ALERT SERVICE BULLETIN

430-14-54

Revision C, 22 February 2017

SUBJECT: GOODRICH EXTERNAL HOIST

Figure 1. Lower limit for the 600 lb capacity hoists

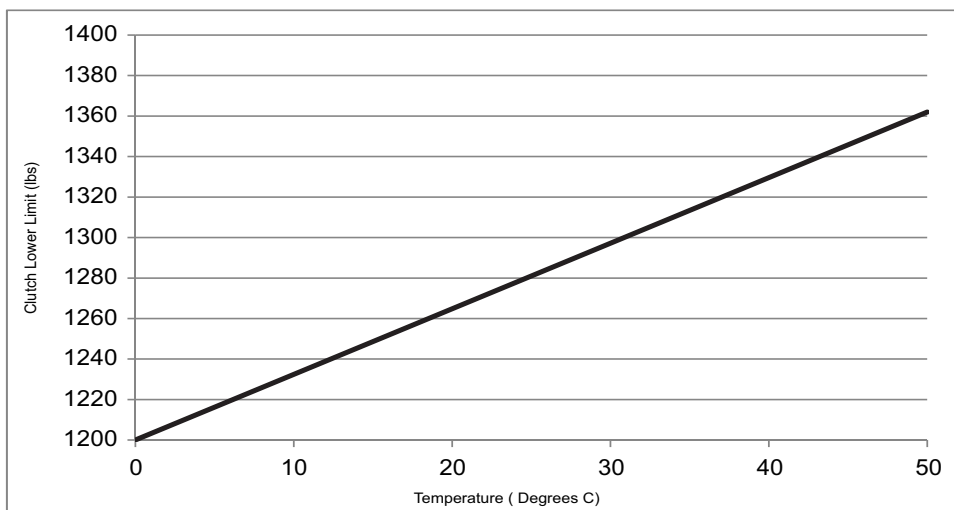
- a. If the test results indicate a value above the acceptable lower limits per Table 2 and Figure 1 of Goodrich ASB 44301-10-18 Revision 6, proceed with step 3.

- b. If the test results indicate a value below the acceptable lower limit per Table 2 and Figure 1 of Goodrich ASB 44301-10-18 Revision 6, remove the hoist from service before the next hoist operation.

Figure 3. Load check flowchart

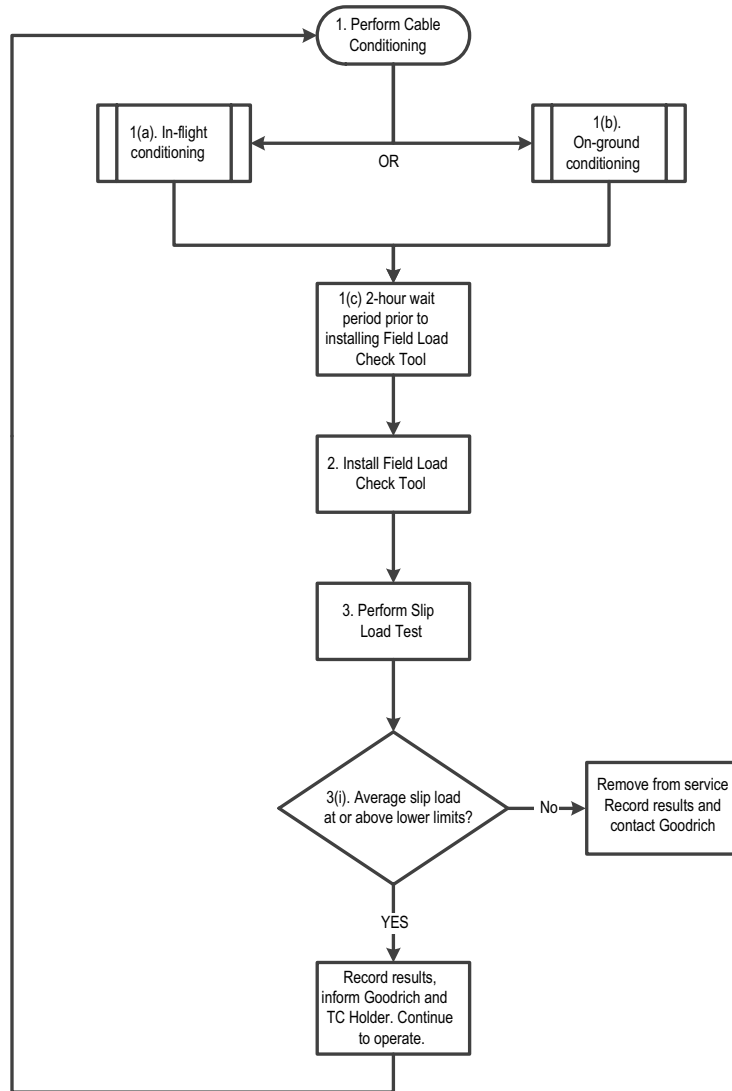
- (a) Press the Peak button on the load meter.
- (b) Using the box wrench provided in the kit, tighten the hex nut on the load check tool at a rate not exceeding 90° per second to increase the load on the cable until the clutch slips or until reaching 1500 lbs. If the clutch does not slip at less than 1500 lbs, then record the load as 1500 lbs and stop increasing the load. Decrease load to 600-700 lbs and continue at step 3d.

- (i) If the test results indicate a value above the allowable limits per Table 1, record the results, inform Goodrich and the TC holder, and continue operations.
- (j) If the test results indicate a value below the acceptable lower limit per Table 1, obtain a return authorization for the failed hoist using the standard RMA process through Goodrich at the address listed below. Send results of testing to Goodrich.
